# UNITED STATES PATENT AND TRADEMARK OFFICE

10/579,852

<b>Office Action Summary</b>	<b>Application No.</b> 10/579,852	<b>Applicant(s)</b> VAN DER LINDEN ET AL.	
	<b>Examiner</b> WILLIAM MCCALISTER	<b>Art Unit</b> 3753

3. Claims 8-11, 14 and 15 are rejected under 35 U.S.C. 102(e) as being anticipated by Talaski (US 2005/0016599).

**Annotated FIG 8**

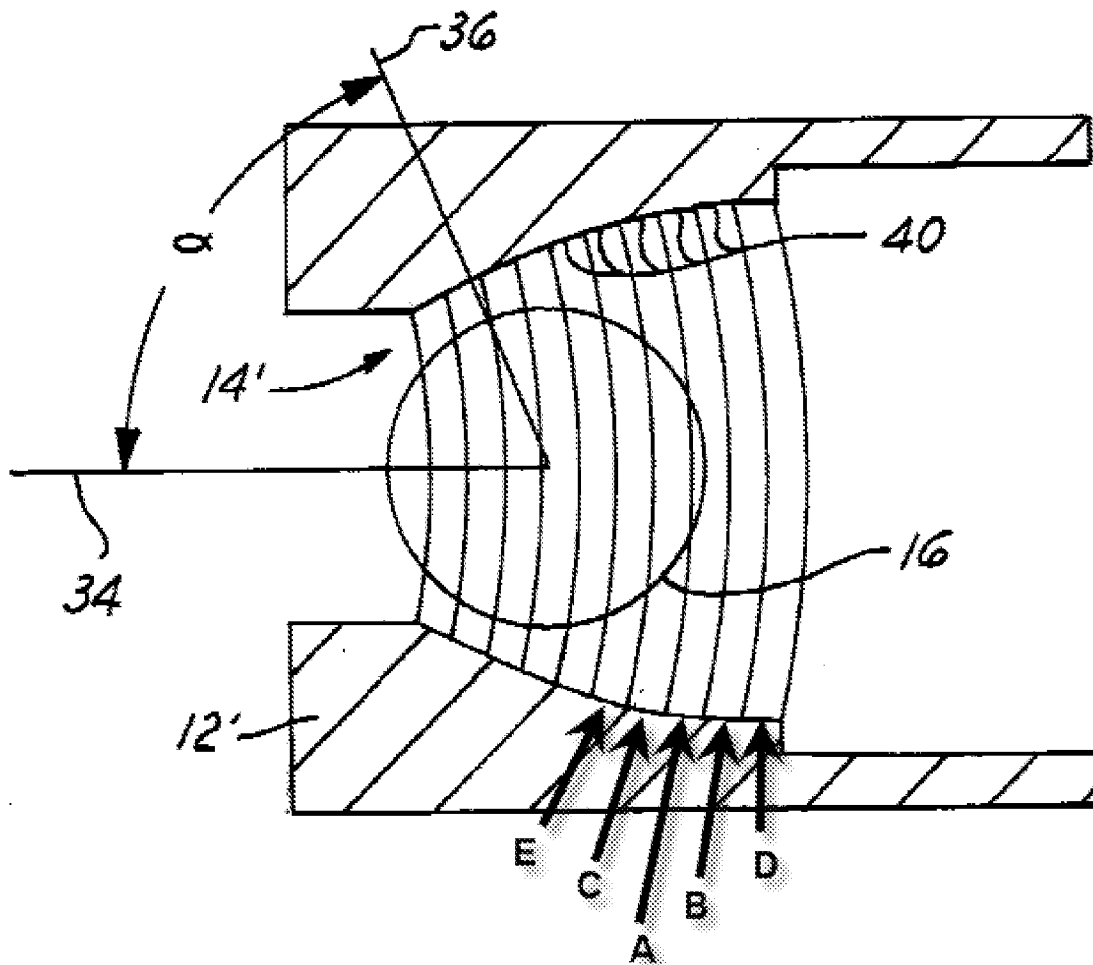
Regarding claim 8, Talaski discloses (see annotated FIG 8, below) a valve having a valve member (16) which cooperates with a valve seat (14') formed in a housing part (12') in order to control a connection, the valve seat having an at least approximately conical seat face (A) which is located at a transition of the connection from a portion of small diameter (left, FIG 8) to a portion of large diameter (right, FIG 8), wherein the seat face (A), on its side oriented toward the portion of large diameter (right), is adjoined by at least one face (B) which is more markedly inclined toward the longitudinal axis of the connection than the seat face (angle  $\alpha$  is larger, see explanation in paragraphs 21 and 27) and wherein the seat face, on its side oriented toward the portion of small diameter, is adjoined by at least one face (C) which is less markedly inclined toward the longitudinal axis of the connection than the seat face (angle  $\alpha$  is smaller).

Regarding claim 9, Talasaki discloses the face (B), adjoining the seat face (A) toward the portion of the connection having the large diameter (right), to be adjoined by at least one further face (D), inclined more markedly toward the longitudinal axis of the connection (angle  $\alpha$  is further increased).

Regarding claims 10 and 11, Talasaki discloses the face (C) adjoining the seat face (A) toward the portion of the connection having the small diameter (left) to be adjoined by at least one further face (E), inclined less markedly toward the longitudinal axis of the connection (angle  $\alpha$  is further decreased).

Regarding claims 14 and 15, the side of the connection from which the surfaces are machined would not impart any distinctive structural characteristics. This process of manufacture therefore does not further define the claimed valve.

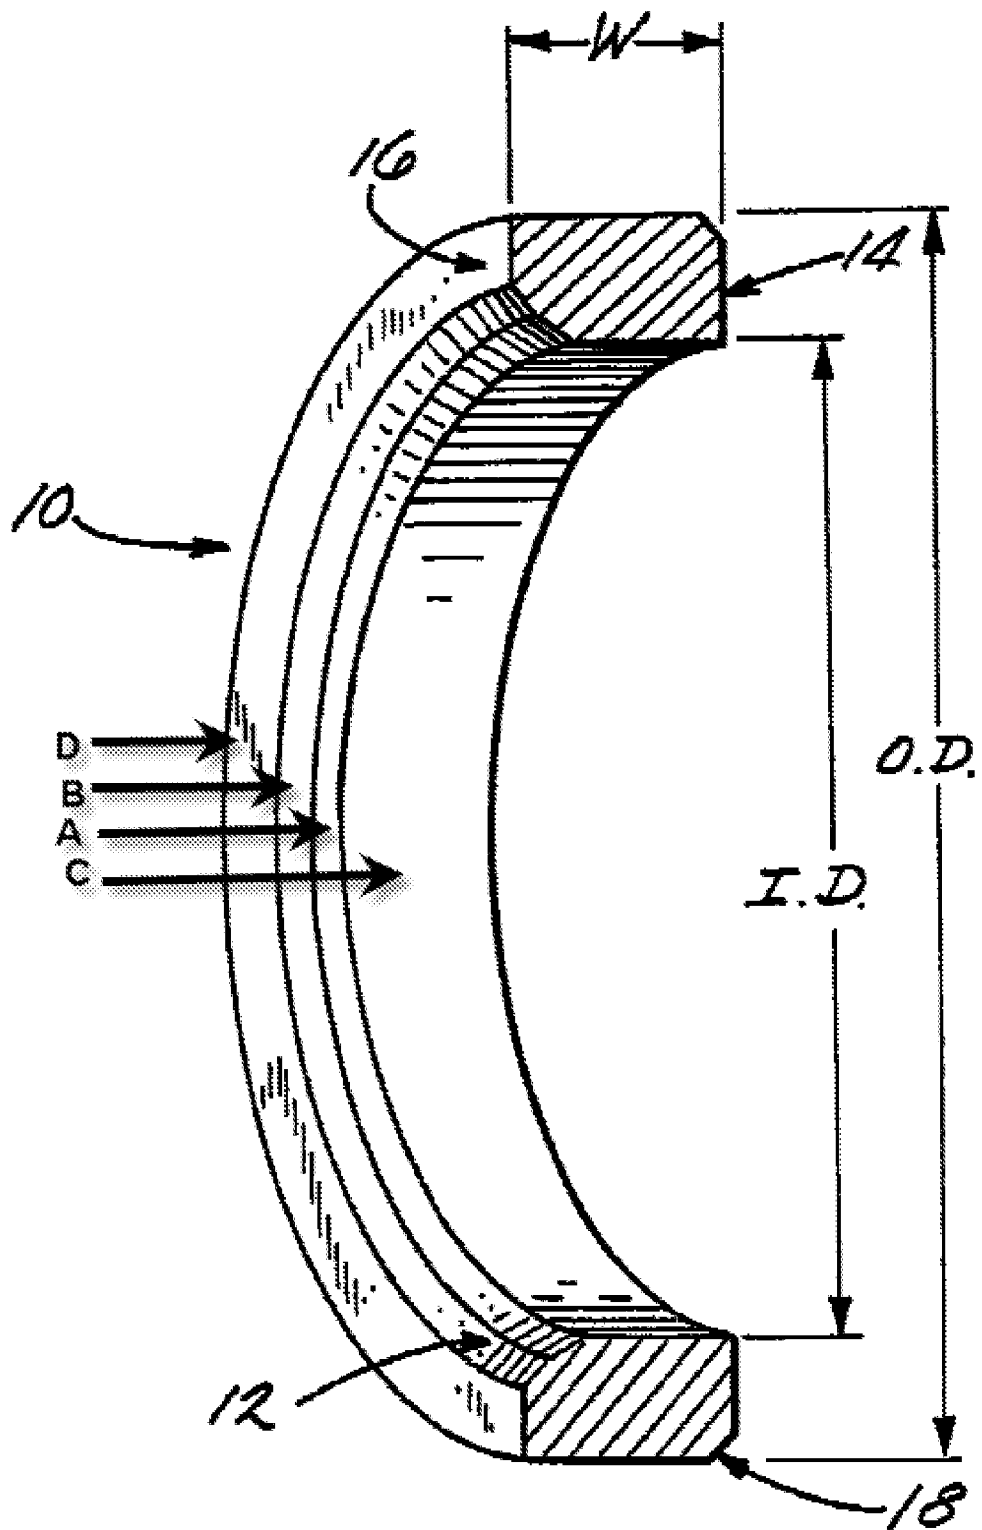
Regarding claim 8, Trudeau discloses a valve having a valve member (inherent) which cooperates with a valve seat (see annotated FIG below) formed in a housing part in order to control a connection (inherent, to contain and control flow), the valve seat having an at least approximately conical seat face (A) which is located at a transition of the connection from a portion of small diameter ("ID") to a portion of large diameter ("OD"), where the seat face (A), on its side oriented toward the portion of large diameter, is adjoined by at least one face (B) which is more markedly inclined toward the longitudinal axis of the connection than the seat face (A) (for purposes of the following analyses, the angles are defined as those between the longitudinal axis and a line perpendicular to the face in question; in this case the angle defined in part by face B is smaller than that defined in part by face A, and is therefore "more inclined toward" the longitudinal axis) and wherein the seat face (A), on its side oriented toward the portion of small diameter, is adjoined by at least one face (C) which is less markedly inclined toward the longitudinal axis of the connection than the seat face (angle is larger).

Regarding claim 9, Trudeau discloses the face (B), adjoining the seat face (A) toward the portion of the connection having the large diameter, to be adjoined by at least one further face (D), inclined more markedly toward the longitudinal axis of the connection (angle is further decreased).

Regarding claims 14 and 15, the side of the connection from which the surfaces are machined would not impart any distinctive structural characteristics. This process of manufacture therefore does not further define the claimed valve.

Regarding claims 18 and 19, Trudeau's faces are hardened (col. 1 line 66).

Trudeau discloses the invention as claimed, including four faces (A, B, C, D) of progressive angular orientation, but does not disclose the fifth face as required of the claims. However, it would have been obvious to one of ordinary skill in the art at the time of invention to employ a fifth seat face, since it has been held that mere duplication of the essential working parts of a device involves only routine skill in the art. *St. Regis Paper Co. v. Bemis Co.*, 193 USPQ 70.
